Preliminary Consultation MONTGOMERY COUNTY HISTORIC PRESERVATION COMMISSION STAFF REPORT

Address: Smith Drive., Silver Spring Meeting Date: 11/12/2025

National Park Seminary Historic District

Proposal: Building Rehabilitation of the Castle and Villa Buildings and Construction of a New

Figure 4: East elevation of the Castle.

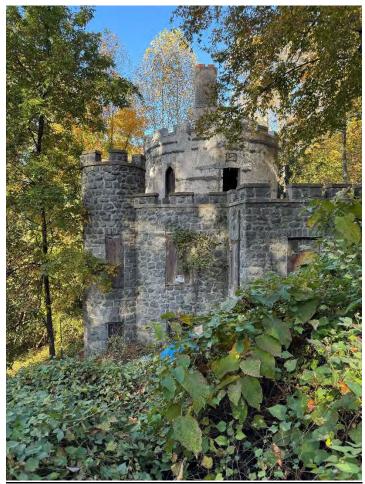
In response to the submission, Staff has several questions related to the rehabilitation of the Castle.

- What plans has the Maryland Historical Trust reviewed?
- Are there any extant historic doors and windows installed behind the plywood?
 - o If so, what is their condition?
- What re-grading is proposed for the area immediately adjacent to the Castle?

Additionally, Staff has identified the following materials as necessary for the HPC to make a determination of appropriateness. These materials should be included in a submission for a second Preliminary Consultation.

- Existing and proposed Castle floorplans;
- Proposed elevation drawings;
- Detailed specifications for the treatment of the exterior walls;
- Material specifications for the doors windows;
- Any interventions necessary to satisfy contemporary building codes (i.e., ADA access, egress requirements, etc.).

Figure 16: Section of the site plan showing the proposed reforestation area.

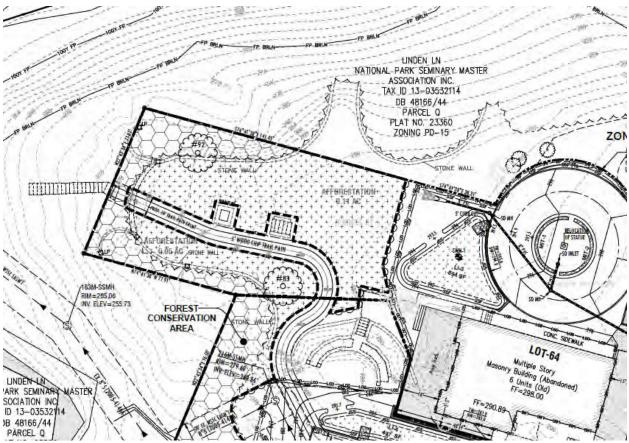
Staff does not find the proposed reforestation area is an appropriate treatment for what had historically served as a formal open space. Staff recommends this area be returned to a formal open space and the historic stone wall be restored. Additional discussions with Planning Department Staff on the appropriate location to satisfy the requirements of the Forest Conservation Plan should include HPC Staff to ensure the preservation of the cultural landscapes on site.

1 OF 4. EXISTING CASTLE ELEVATIONS

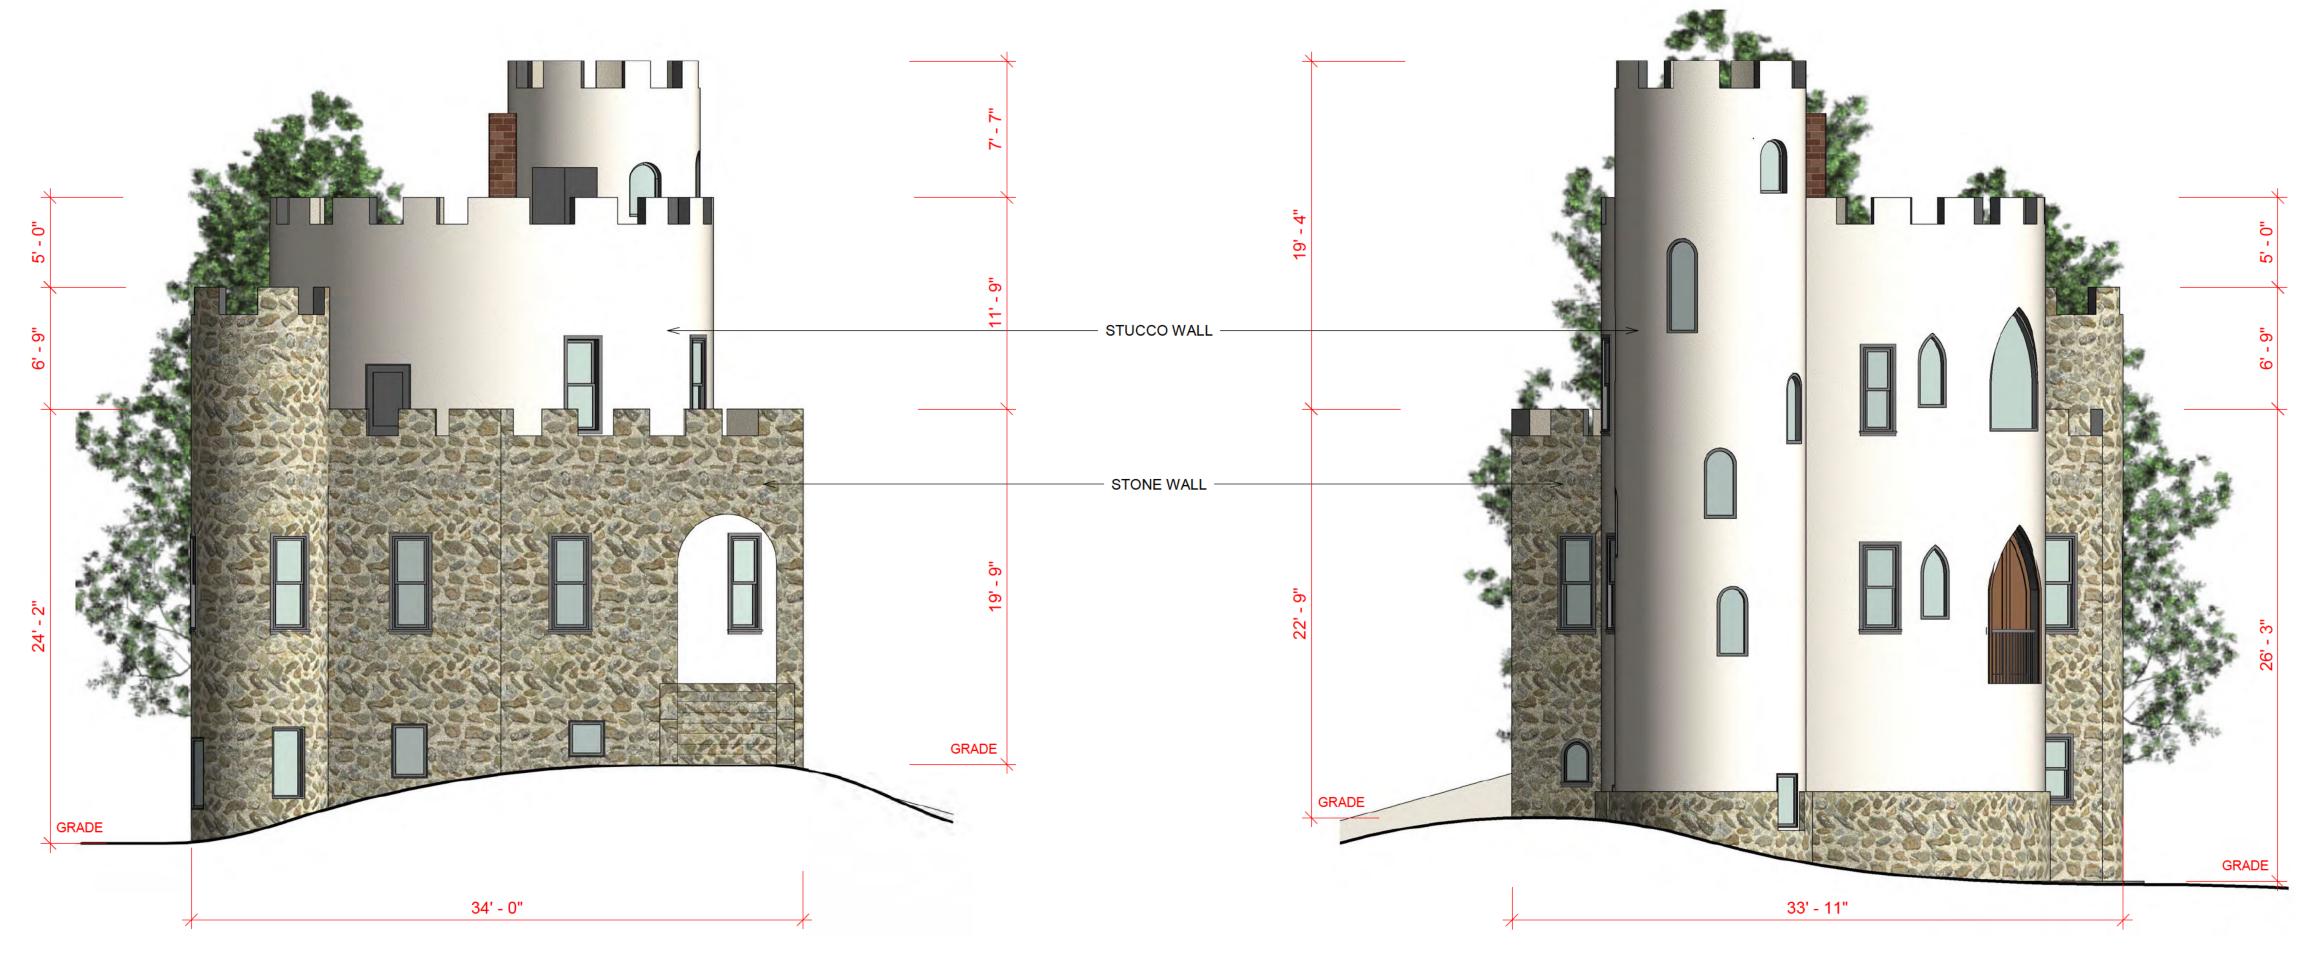
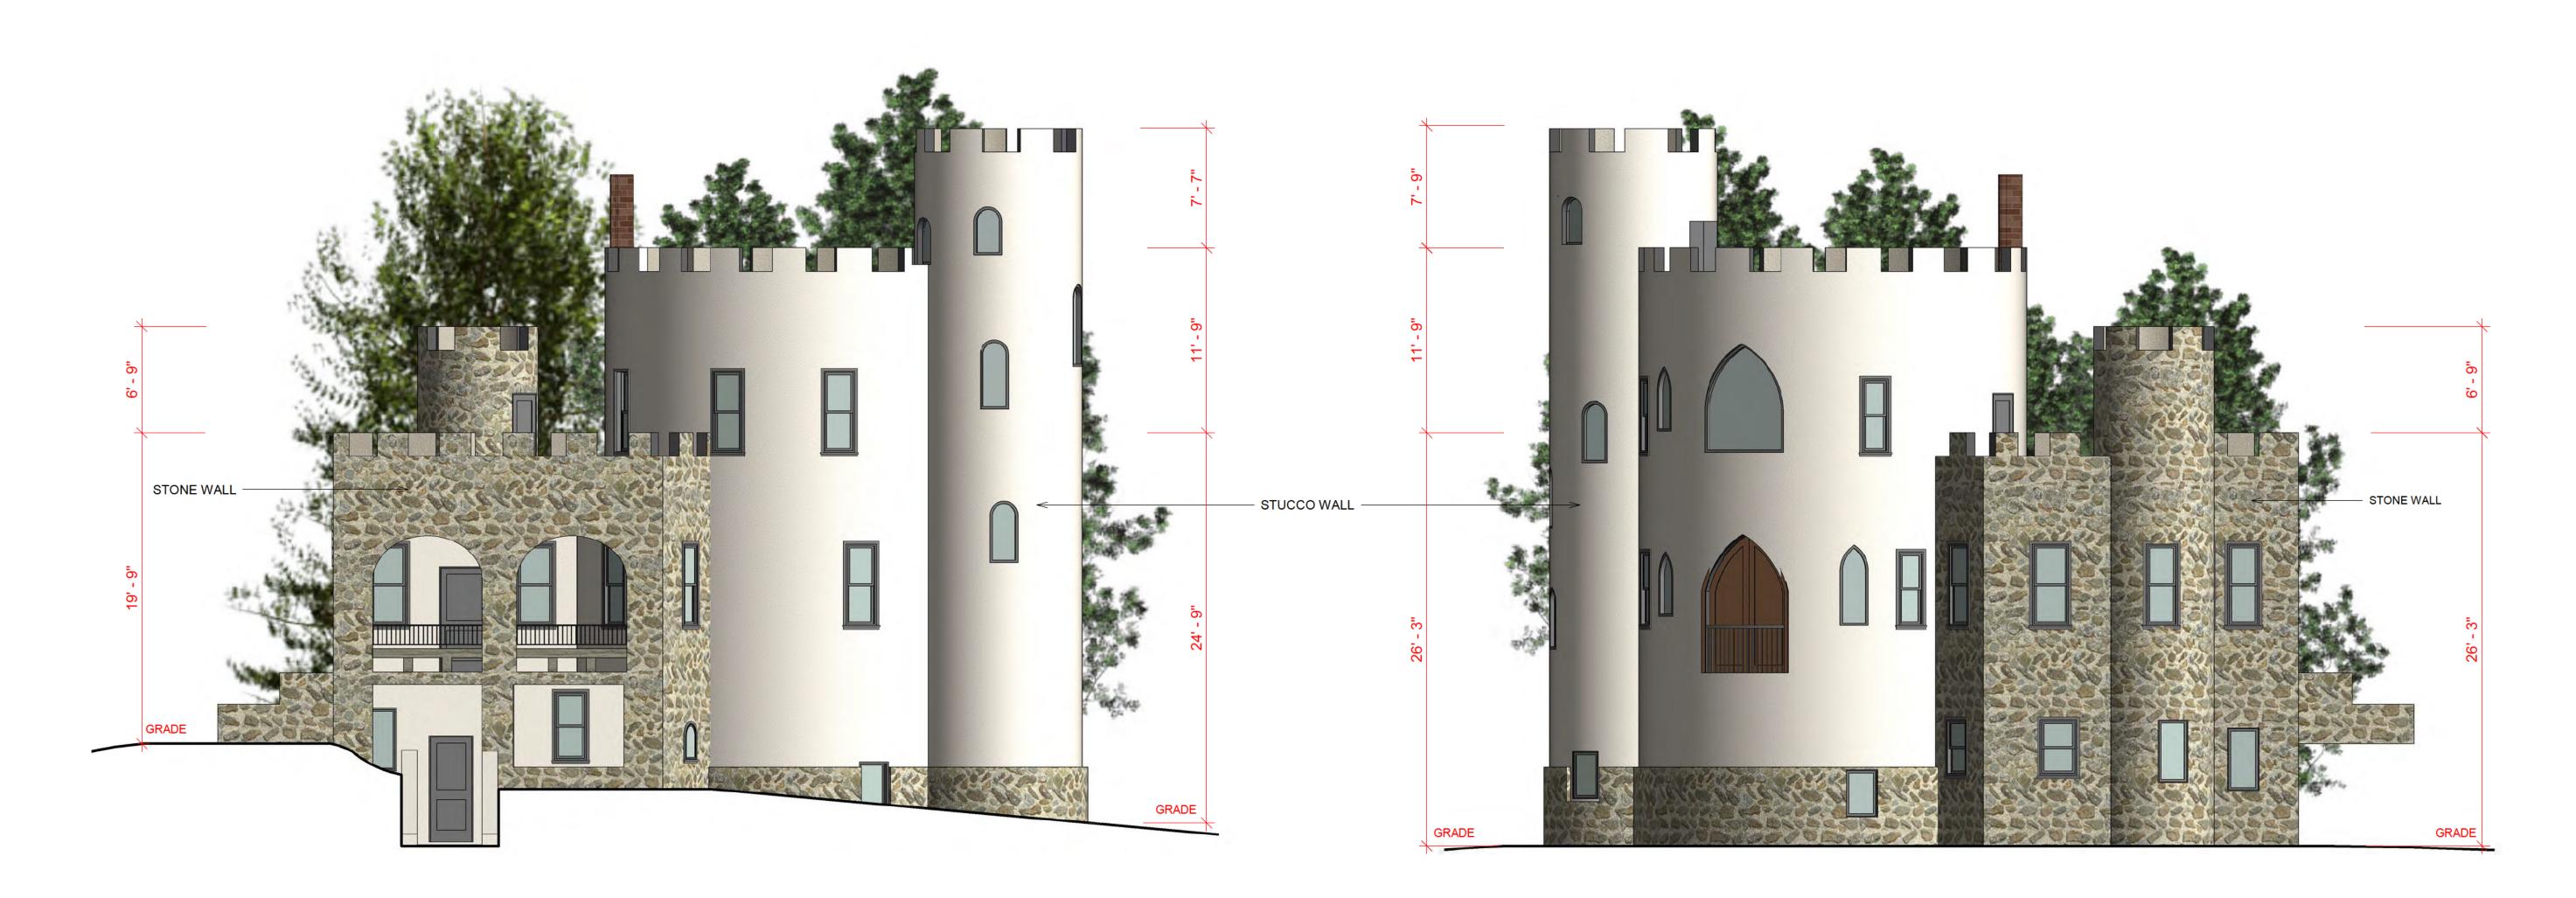
Staff requests feedback from the HPC regarding:

- The treatment of the exterior of the Castle;
- The completeness of the necessary materials identified by Staff; and
- Any additional materials or information to be included at the next Preliminary Consultation.

2 OF 4. VILLA ELEVATIONS: EXISTING & PROPOSED SECTIONS

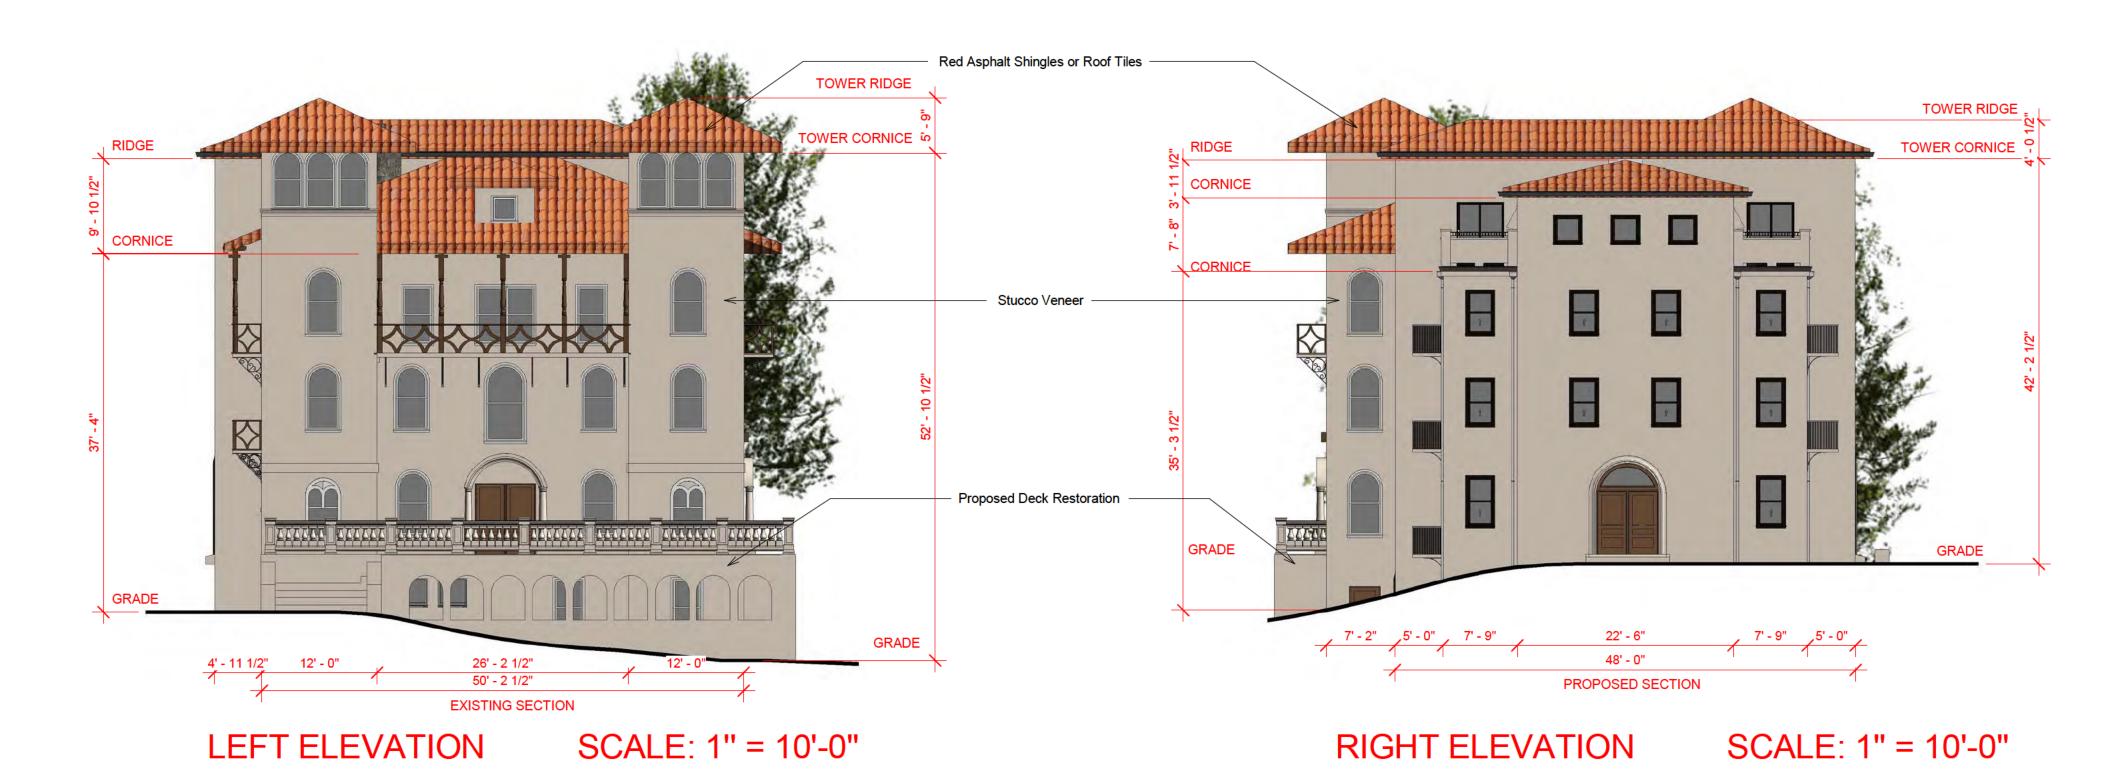
Staff previously provided comments to the applicant that it did not find the proposed addition satisfied the *Secretary of the Interior's Standards for Rehabilitation*. This finding was largely based on the proposed size, massing, and the fenestration pattern of the proposed addition. The north elevation of the addition, including the new tower is 98' (ninety-eight feet) long, compared to only 77' 5 ½" (seventy-seven feet and five and one-half inches) for the original construction. The floorplans included in the easement documents show that the demolished rear portion was approximately 50% (fifty percent) of the total size of the building, however, the 30° angle helped to obscure its overall size (see *Figure 5*, above). The proposed addition will more than double the length of the north elevation. Additionally, the site plan shows that the centrally located tower will project beyond the north wall plane of the historic building. Staff finds additional revisions to the size, massing, and design are required to satisfy the *Standards*.

While Staff is generally reluctant to provide too much feedback on the design of the proposed addition at the risk of making recommendations that run counter to the MHT Easement committee, Staff finds that addition's design needs to be revised so that it has less visual impact on the historic construction. The applicant could use the form of the historic construction to help reduce the visual impact the addition will have on the Villa.

Staff's other preliminary comment is related to the proposed front deck. The submitted drawings identify this as a 'restoration.' Staff does not find the current deteriorated wood stairs to be the historic design, Staff is concerned that the scale and design of the proposed stairs risks creating a false sense of history, running afoul of *Standard #3*. Staff encourages the applicant to conduct additional research to identify a historic image of the Villa that will help to aid in the design of the front porch and/or confirm its overall size and design. An undated historic photograph (below) shows a portion of the front of the Villa, but is not clear enough to help identify materials and overall dimensions.

In response to the submission, Staff has several questions related to the rehabilitation of the Villa.

- What plans has the Maryland Historical Trust reviewed?
 - o What is the feedback to date?
- Are there any extant historic doors and windows installed behind the plywood?
 - o If so, what is their condition?
- The plans identify a proposed deck restoration. Has the applicant located any historic photos beyond what has been presented in this Staff Report that show this deck, or are its design and dimensions conjecture?

Additionally, Staff has identified the following materials as necessary for the HPC to make a determination of appropriateness. These materials should be included in a submission for a second Preliminary Consultation.

- Detailed documentation of the existing building condition;
- Existing and proposed Villa floorplans;
- Proposed notated elevation drawings;
- Detailed specifications for the treatment of the exterior features;
- Material specifications for the doors windows;
- Any interventions necessary to satisfy contemporary building codes (i.e., ADA access, egress requirements, etc.).
